Quality Control Check Report. Stages: After Finishing Stage II (Apartments)

Flat No	A-117	Other		SL No.	41969
Company	MRGV	Project	BRGv	Phase	-
Prepared by	P. Bhargava	Sign	[Signature]	Date	20-06-23
Project Manager	[Signature]	Sign	[Signature]	Date	20-06-23
Previous stage report no.	41389	Report filed and signed by PM		Yes ☒ No ☐	
Checked By MD on		MD Sign		For filling	Yes ☐ No ☐

Details of Additions & Alterations

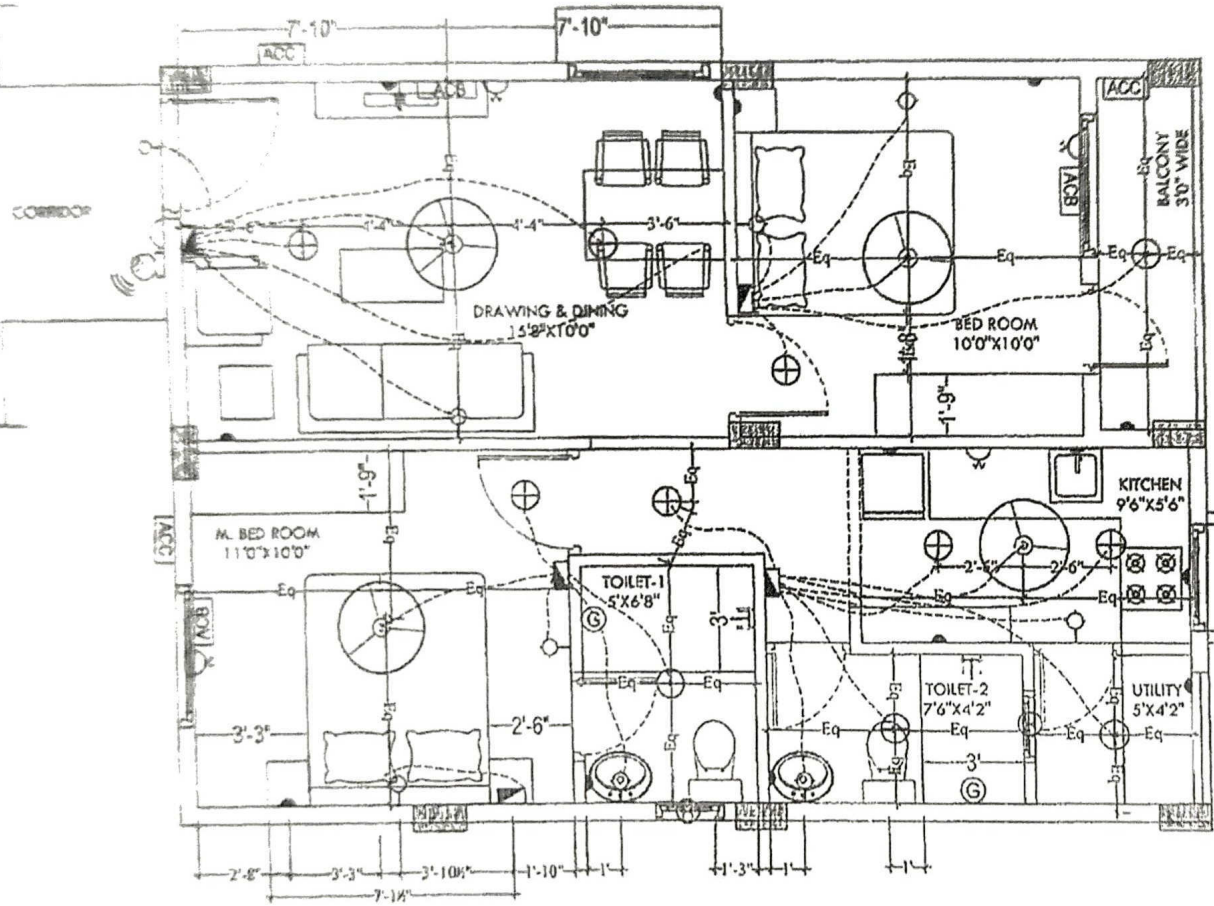
- 1) Main entrance of 117 flat should be close.
- 2) In 117 flat, Second Bedroom Balcony railing partially close with small gate.
- 3) In 118 flat, Entrance has to N-E corner.
- 4) No kitchen in 117 flat.
- 5) Door should be on common wall of 117 & 118 flat.
